File 1982-0031
Date 6/12/02

Project Name: Horizon Park Plaza – Development in HO-Office Building

HORIZON PARK OFFICE BUILDING
IMPACT STATEMENT

FILE NO. 31-82 TITLE HEADING Three Story Speculative Office Building DUE DATE 4/12/82
 ACTIVITY - PETITIONER - LOCATION - PHASE - ACRES Petitioner: Horizon Company/Stephen Owen.
 Location: East of Horizon Court and West of the Highline Canal. A request for a final plan on 2.85 acres in a highway oriented zone. Consideration of development in HO.

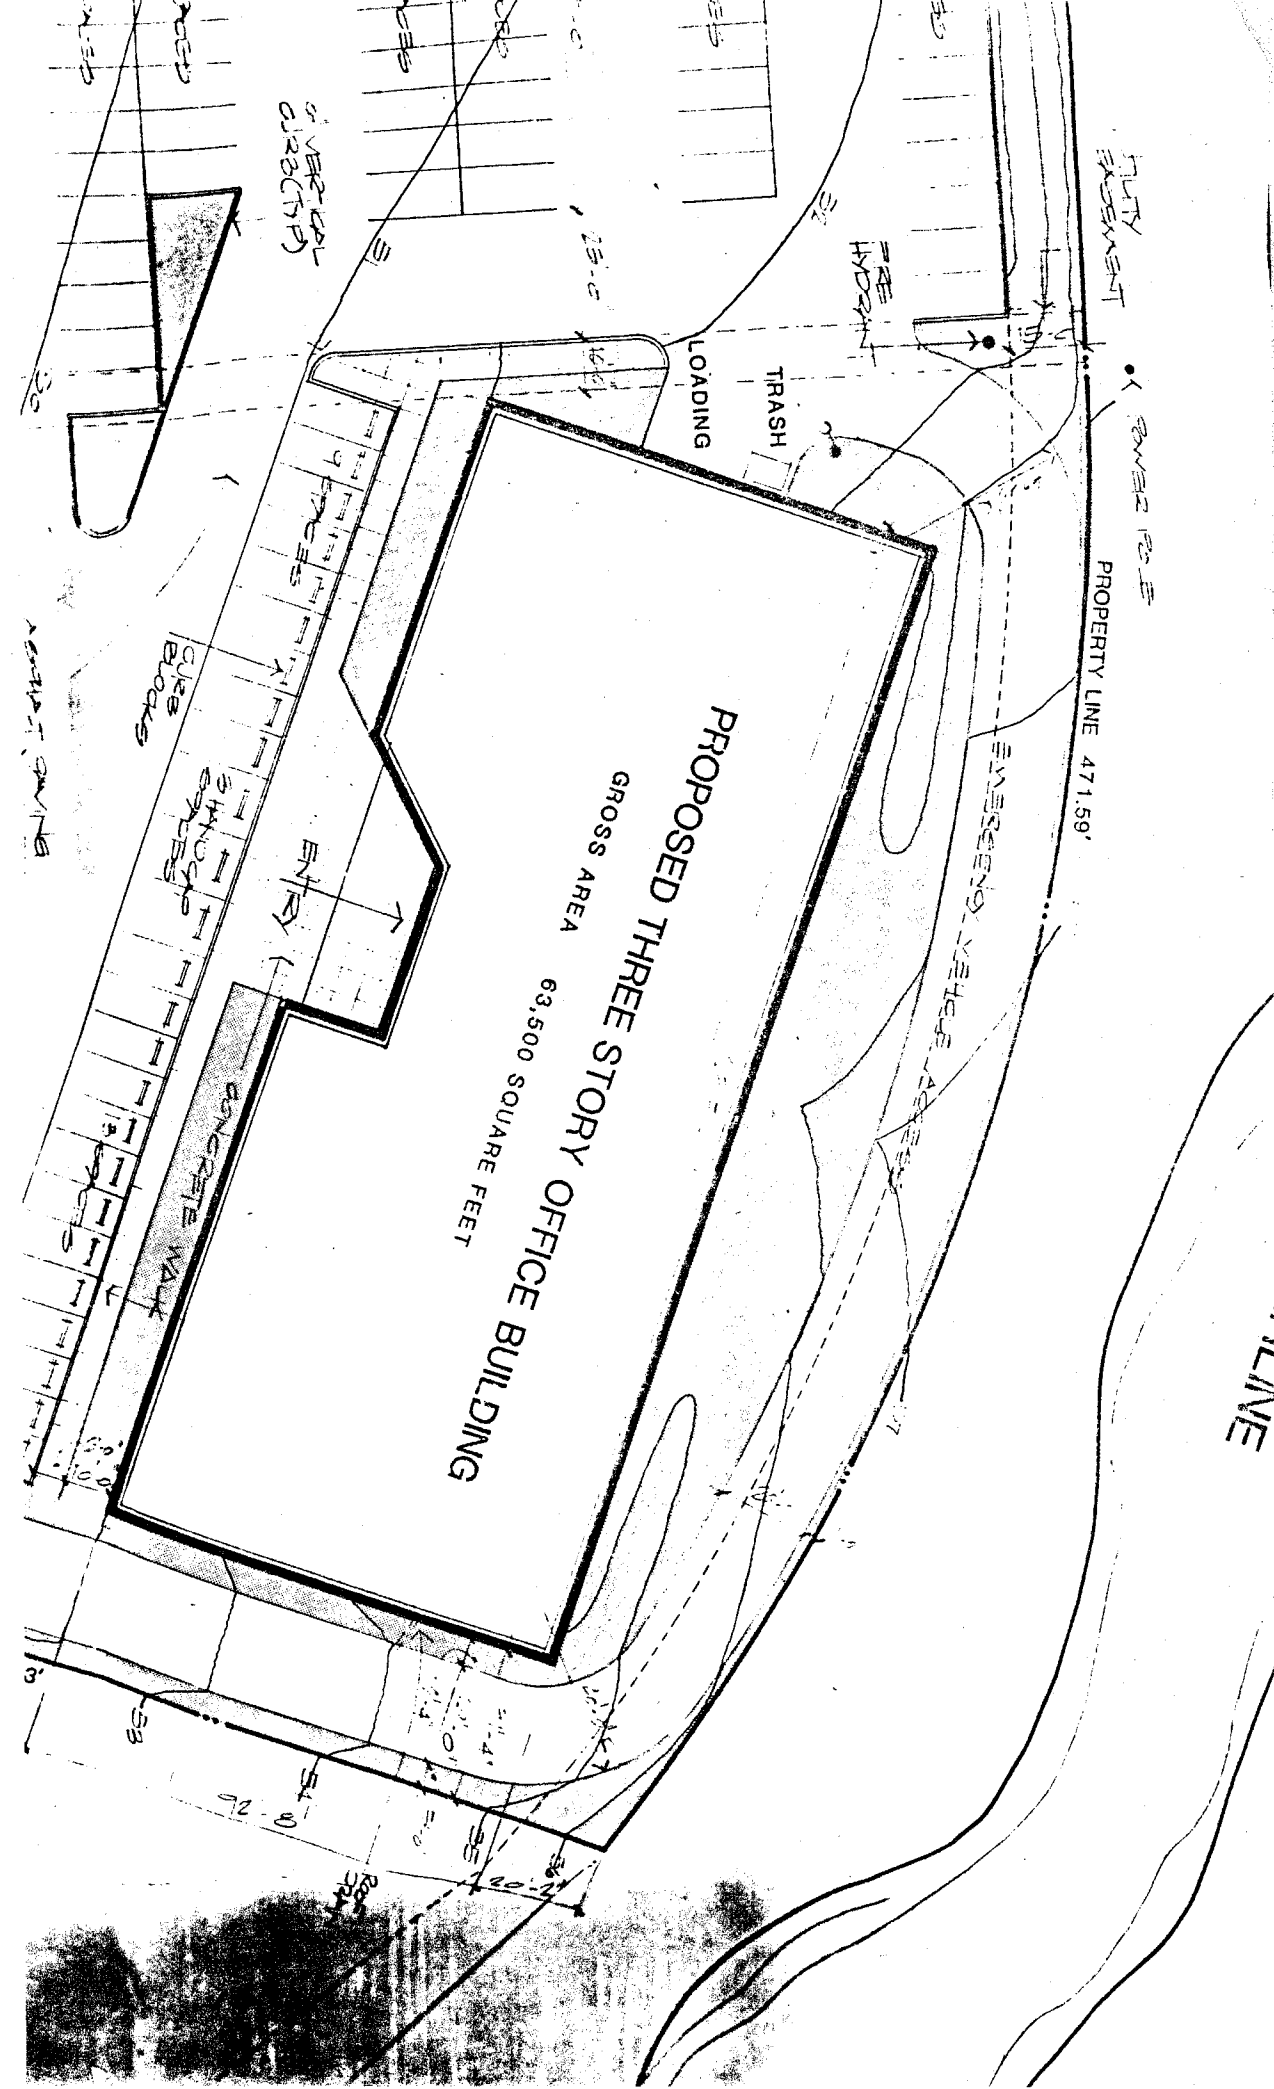
<u>DATE REC.</u>	<u>AGENCY</u>	<u>COMMENTS</u>
4/13/82	City Fire	This office is unable to approve the development at this time as we have not received adequate information concerning type of construction, interior fire protection, and water main size for proposed fire hydrant. There will also be the need for additional hydrant(s) on the property. Please re-submit, showing type of construction and additional on-site hydrants. Access for emergency equipment must be provided in the rear of building along canal. Fire equipment access must be a minimum of 20 feet unobstructed width.
4/9/82	City Utilities	Utilities are not shown.
4/9/82	Mountain Bell	No requests.
4/6/82	Airport Authority	No particular problems relative to the airport are apparent with this proposed facility providing height (of appendages/antennas) and skyward lighting are reasonably addressed; the aviation easement enclosed with the application is acknowledged. The use appears compatible with adjacent land use and is separated from airport property by the Highline Canal.

4/12/82	Trans. Engineer	First two parking spaces in SW corner should be eliminated in order to reduce conflicts at the entrance. Bumper stops should be provided for all parking stalls along walks to prevent vehicles from protruding over walk.
4/7/82	Ute Water	No objections to the development. An existing 8" line in Horizon Court will serve the site. Domestic meter size will be determined following receipt of a Peak Demand-Data Sheet. Policies and fees in effect at the time of application will apply.
4/8/82	Bureau of Reclamation	The Bureau of Reclamation claims rights of way on all water conveyance systems, associated with the Government Highline Canal and Lateral Systems. The rights of way in most cases are by prescription for construction, re-construction, operation and maintenance. The United States claims by prescription a right of way 70 feet on the west side of center line and 50 feet on the east side of center line of the Government Highline Canal in that portion of the "Horizon Park Plaza Subdivision" which lies in Section 31, T1N, R1E, Ute Principal Meridian. The remaining portion of the "Horizon Park Plaza Subdivision" is bounded by recorded deeds which cover the canal boundaries.

<u>DATE REC.</u>	<u>AGENCY</u>	<u>COMMENTS</u>
4/13/82	Planning Staff Comments	NOTE: This is Development in H.O. which is a one-step final plan. All issues need to be resolved prior to the public hearing. <ol style="list-style-type: none">1. Need elevations detail and dimensions.2. Curb blocks should be utilized, especially parking along Horizon Ct.3. Pedestrian traffic should be separated from vehicular traffic with pedestrian crosswalks.4. Trash pick-up needs to be coordinated with Bill Reeves, Sanitation Engineer.5. New curb cuts should be coordinated with the appropriate agency.6. Lighting scheme should be shown and detailed.7. Signage should be shown and detailed.8. Drainage should be approved and resolved by the appropriate agency.9. Setback of structures should be indicated on plan.10. An avigation easement has been submitted already.
4/15/82	City Engineer	Sidewalk should be installed on Horizon Court by the petitioner. A permit from the City Engineer is required for this work in the public right-of-way. Curb cuts should be to City Standard and will require a permit for the construction work along with the sidewalk. Existing utilities should be shown on the plan.

<u>DATE REC.</u>	<u>AGENCY</u>	<u>COMMENTS</u>
5/11/82	Fire Dept.	The 20 foot emergency access in rear of building along highline canal must be all weather surface, capable of supporting the weight of fire apparatus. Please indicate fire line size to on-site fire hydrant. On-site hydrant must be a minimum of 40 feet from building, with a minimum of an 8 inch line. This building will be required to have an approved stand pipe in each stairway.
5/12/82	Planning Staff Comments	The attached maps have been submitted in response to review comments. 1. The overall access has been shown. Needs fire dept. approval. 2. Need to resolve all previous comments as well, (i.e. curb blocks, etc.). 3. This is Dev. in H.O. - final plan - requiring all issues resolved prior to approval by the GJPC & CC.
5/13/82	Ute Water	The existing water main in Horizon Court is 8" with the capacity to serve the proposed project. The Peak-Demand Data Sheet indicates the need for a 3" domestic water meter. Placement of the fire hydrant as indicated and or, if the structure is to have a sprinkled fire protection system, will require installation of a fire line detector check and detector check valve. Policies and fees in effect at the time of application will apply.

5/13/82	City Engineer	This submittal adequately addresses my previous concerns. The petitioner is reminded to obtain a permit from the City Engineer for the curb cuts and sidewalk construction in Horizon Court. Concret aprons as per City standard ST-1 will be required at the driveway entrances.
5/14/82	City Utilities	None.
5/14/82	Trans. Eng.	Bumper blocks should be provided adjacent to sidewalks.

1. The building will be of Type II Fire Resistive Construction.
2. An additional on site fire hydrant will be located near the trash area at the north end of the building.
3. A twenty foot wide access lane will be provided for emergency vehicles along the rear of the building. (See enclosed Site Plan).
4. Fire protection systems for the interior of the building will be designed in accordance with the City of Grand Junction's codes and regulations.

1. First two parking spaces in southwest corner have been eliminated. (See attached Site Plan).
2. Curb blocks will be provided where automobile overhang restricts width of walks.

1. Schematic floor plans and south elevation are enclosed.
2. Curb blocks will be utilized where deemed necessary by design or as required by code or ordinance.
3. Every consideration will be made in regard to pedestrian safety.
4. Trash area is indicated on Sheet A-1. Trash pick-up needs may vary depending on building occupants and will be coordinated with the Sanitation Department accordingly.
5. Curb cut locations have been reviewed by the Traffic Engineering Department. Curb cut design will be detailed in accordance with city standards.
6. Site lighting is shown on the enclosed drawing. Fixture design is shown on the attached cut sheet. Thirty foot poles with double armed high pressure sodium lamps will be utilized.

1. The 20 foot emergency access road will be asphaltic concrete capable of supporting the weight of fire apparatus.
2. Fire line size to the on-site hydrant will be 8".
3. The on-site fire hydrant will be relocated to the north side of the emergency access road approximately 45 feet from the building. This location has been agreed upon by Mr. Wes Payner of the Fire Department and confirmed by Mr. Bob Golden. (See attached Site Plan).
4. The building will be equipped with standpipes in each stairway.

1. Fire Department has reviewed and approved the access road.
2. Other than curb blocks, to our knowledge all other items have been resolved. Curb blocks are shown on the attached Site Plan.

1. Curb blocks are shown on the attached Site Plan.
